## D/DRC Case

1601 Heyward Street

**DESIGN/DEVELOPMENT REVIEW COMMISSION**  
**DESIGN REVIEW DISTRICT**  
**HISTORIC AGENDA**  
**EVALUATION SHEET**  
**Case #1**

**NATURE OF REQUEST:** Request Certificate of Design Approval for exterior changes and preliminary certification for the Bailey Bill.

Left side view

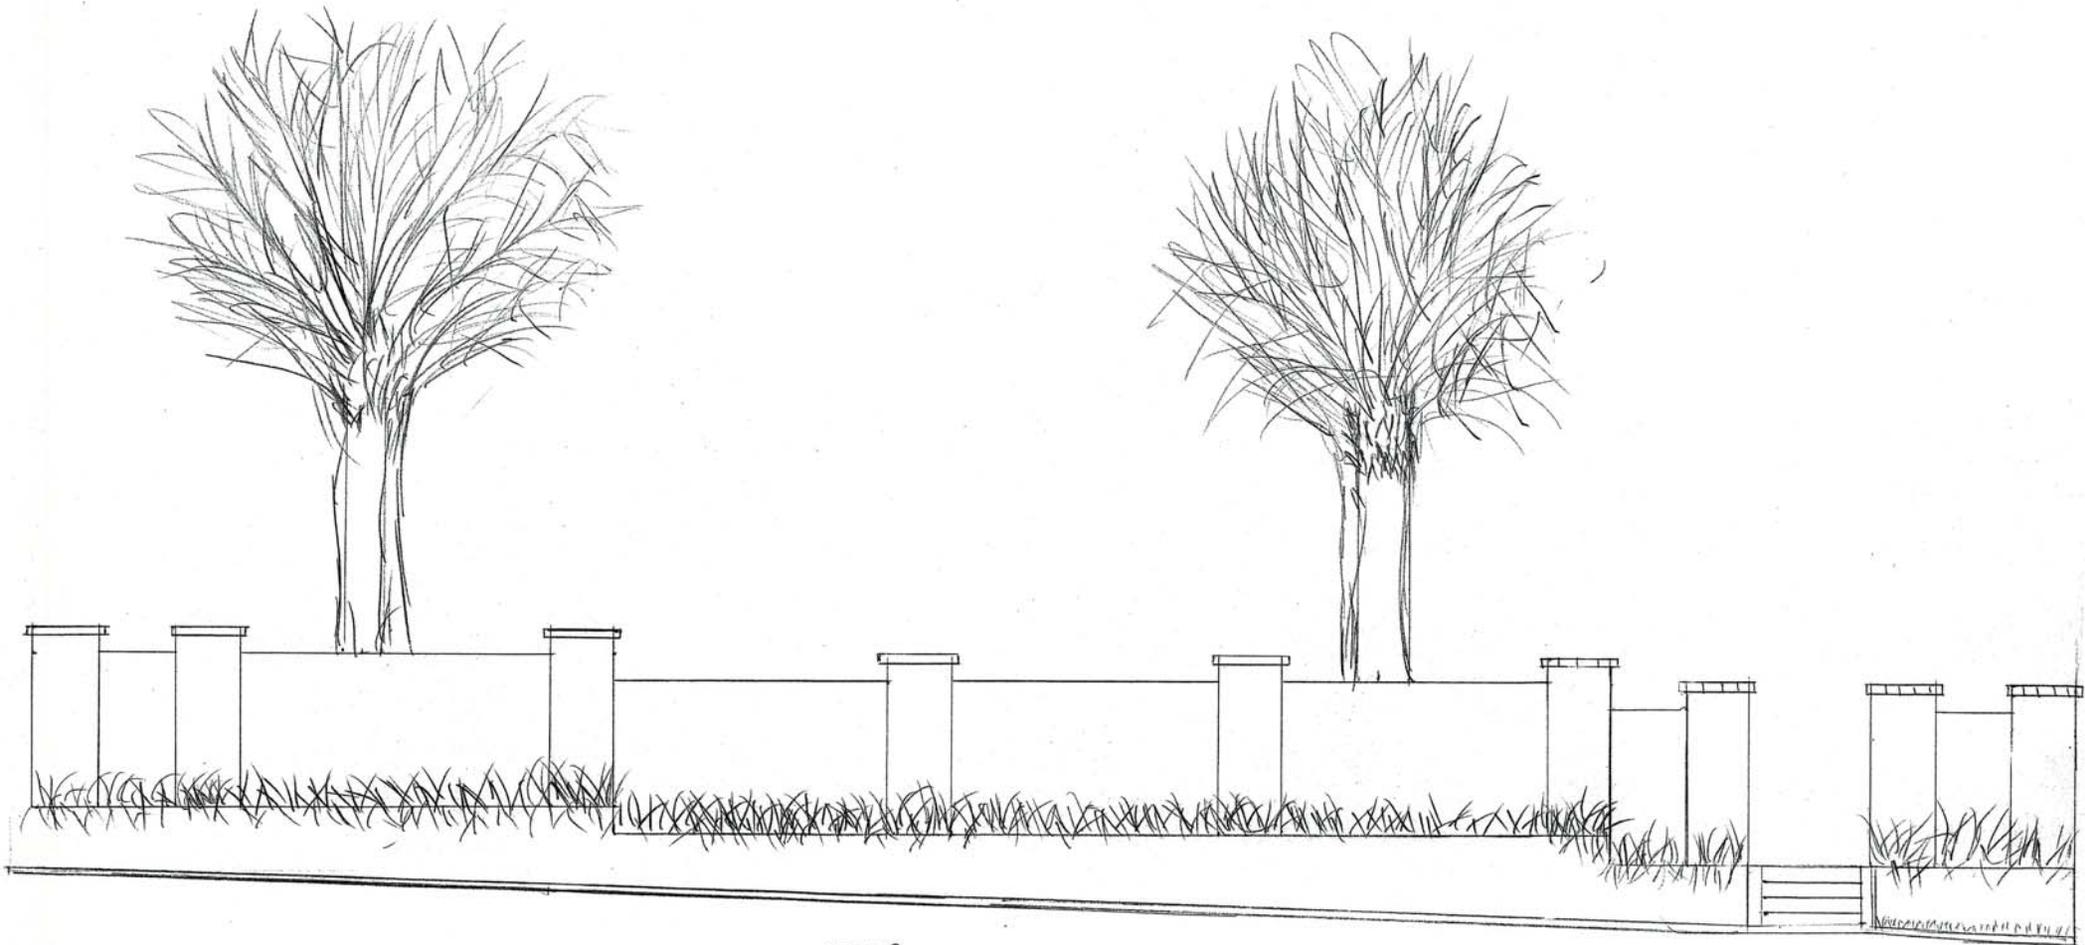
A site plan and elevations for both sides of the addition are included with this evaluation, but no rear elevations have been provided. Staff recommends for the fenestration on the rear of the addition to be consistent with rest of the house; perhaps with six vertically aligned windows with three on the first floor and three on the second floor. An elevation would need to be submitted to staff for review before the project could proceed.

The addition will feature materials and detailing compatible with the original portion of the house. The left side of the addition features a 21' x 8' inset porch on the left side with seven smooth Tuscan columns. Inset porches are not typical in the district, but this feature will be minimally visible once the proposed 6' high brick wall is constructed. The new brick veneer proposed for the addition will match the historic brickwork as closely as possible in material type, size, shape, mortar composition, consistency, color and tooling.

SCALE  
1" = 8'

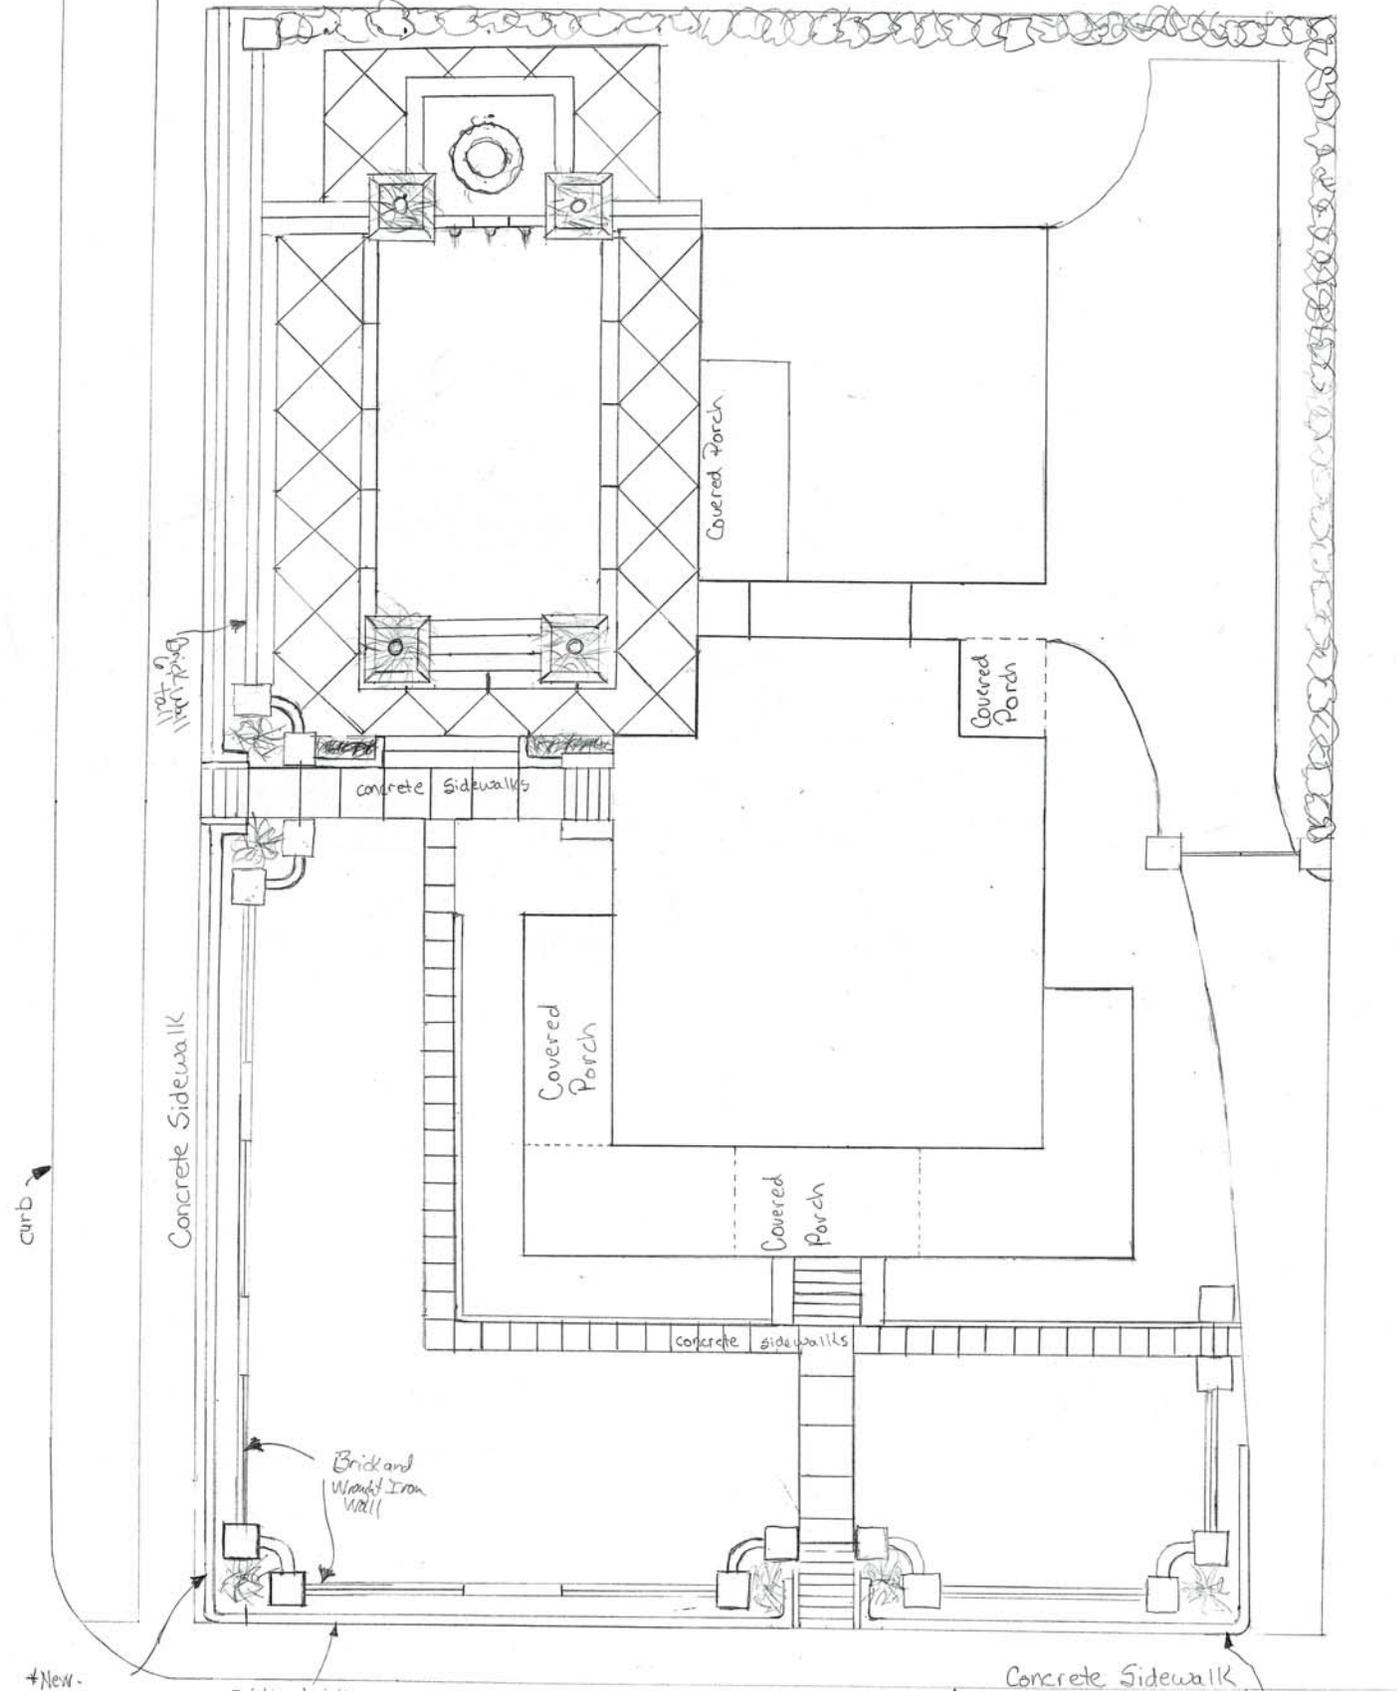
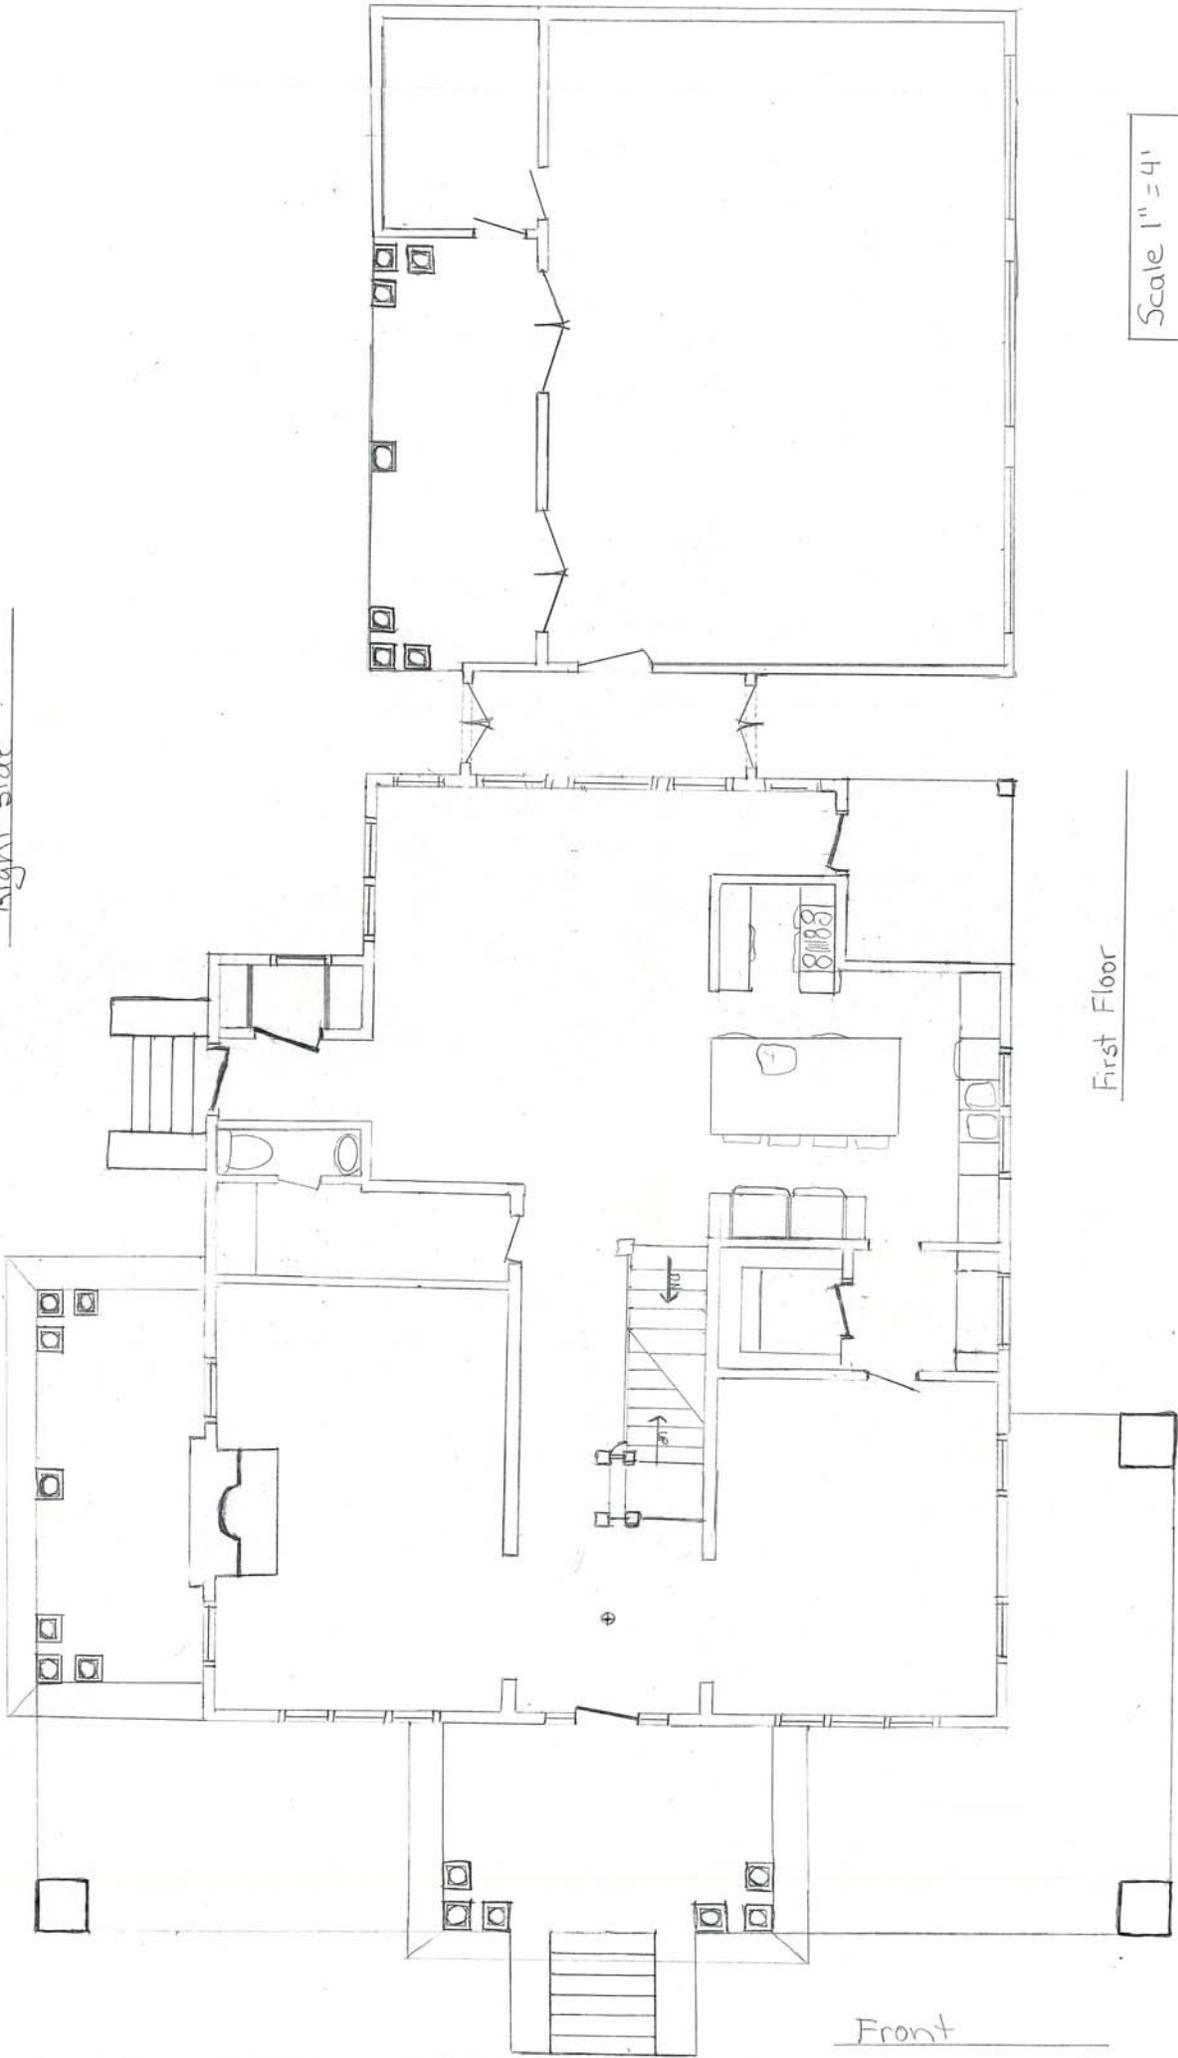
Although the proposed addition is quite large, it is not uncommon to find large historic properties on corner lots within the district. The addition; however, will be highly visible due to the fact that all plants and trees were removed from the property recently. The applicant has proposed installing a 6' high brick wall with landscaping on the Pickens Street side to help minimize the visibility of the addition. The lower portion of the addition will function primarily as a garage; however, the garage doors on the right side will not be highly visible from the public right-of-way as they are approximately 100' from the front sidewalk. The addition will be connected to the house by a hyphen on the second floor only, which should allow for the least amount of alterations to the historic portion. The district's guidelines state to limit the size and scale of an addition so that it is clearly subordinate to the original structure. The proposed addition is definitely smaller than the original, but it is certainly not diminutive. The footprint of the proposed addition is approximately 36% smaller than the existing house and the proposed roofline is approximately 4' lower than the original roofline.

The proposed 32' x 31' addition is situated on the rear of the property and connects to the existing portion of the house via a 14' x 5' hyphen on the second floor. The first floors of the house and the addition will not be connected in order to create a breezeway from one side of the property to the other. As proposed, the addition will not detract from or obstruct important architectural features including the principal façade as it is placed approximately 100' from the sidewalk in front of the house.
